SUBJECT: **Addendum # 1-**
Contract ID: **DC00158** WBS# **17BP.3.R.54**
Brunswick County
REPLACE BRIDGE #197 OVER BRANCH OF WACCAMAW RIVER
ON SR 1333

The subject contract proposal contains the following addendum:

WATTLE BARRIER DETAIL

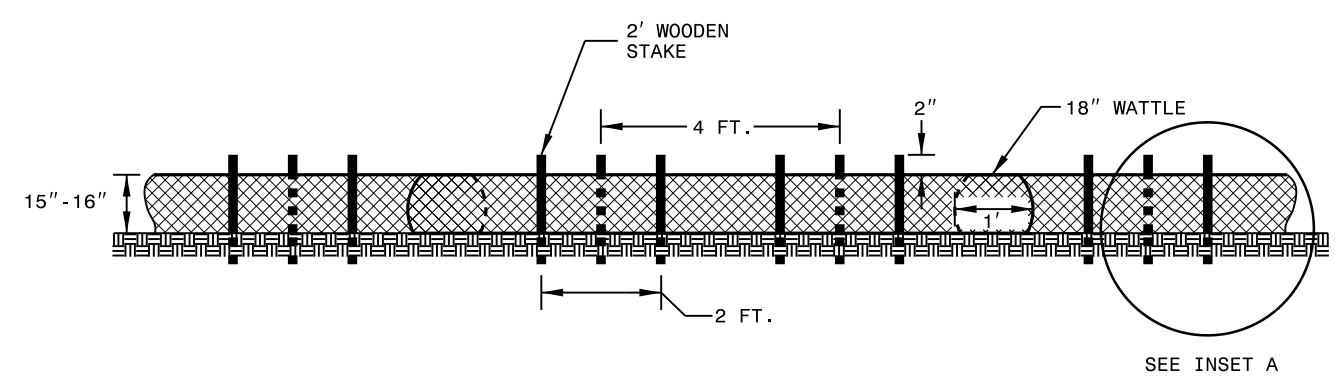
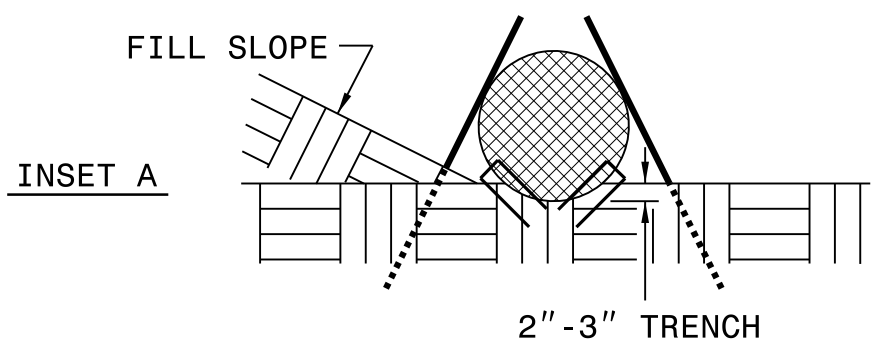
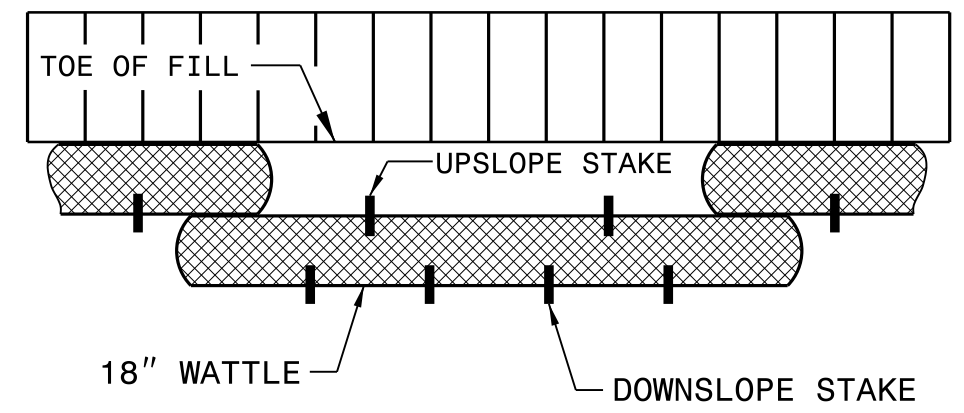
EC-2-“ Wattle Barrier Detail”

WATTLE WITH POLYACRYLAMIDE (PAM) DETAIL

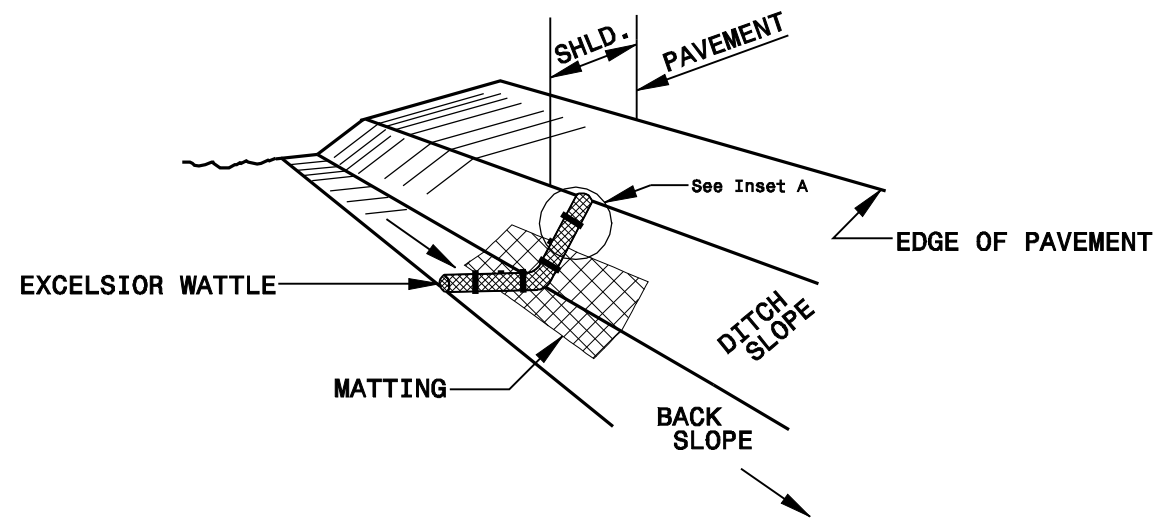
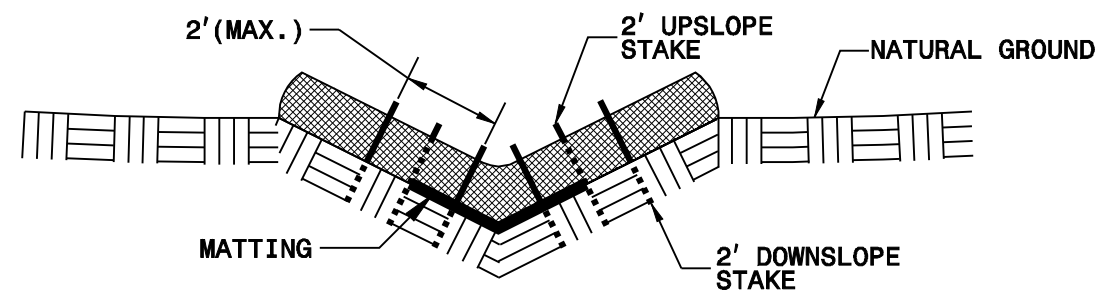
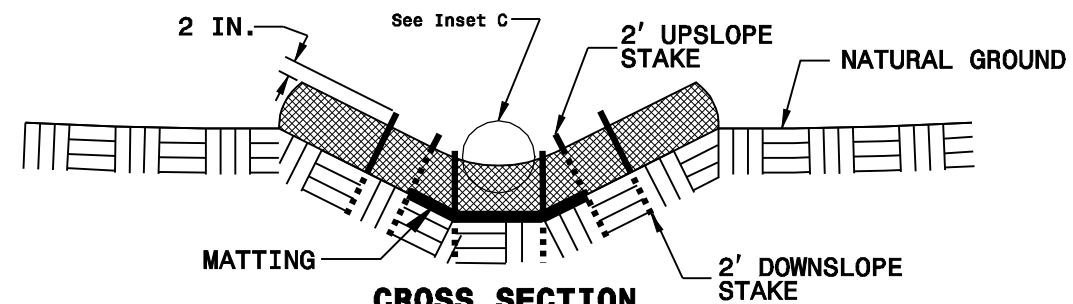
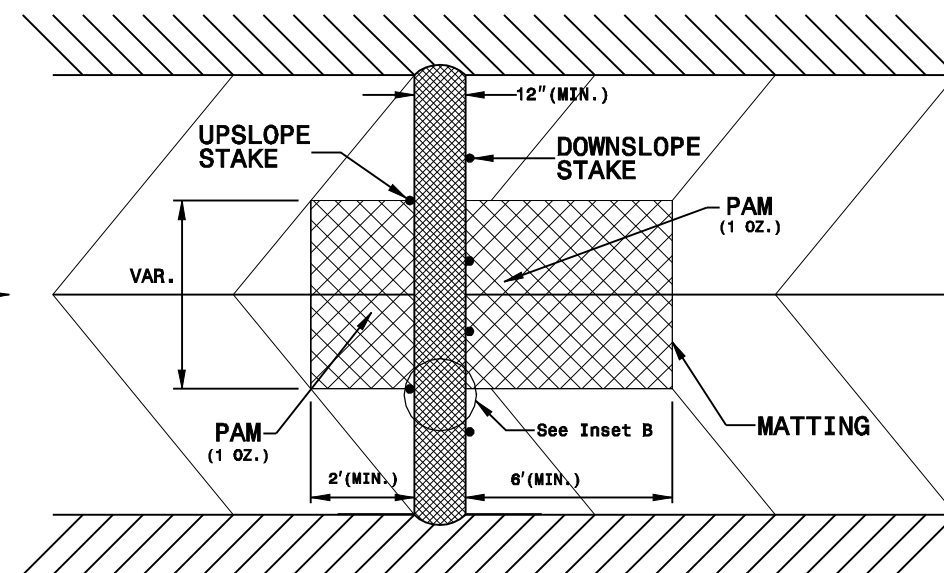
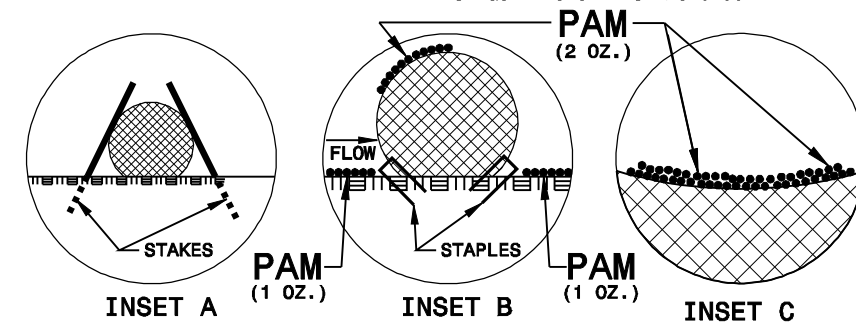
EC-2A-“Wattle with Polyacrylamide(PAM)” Detail
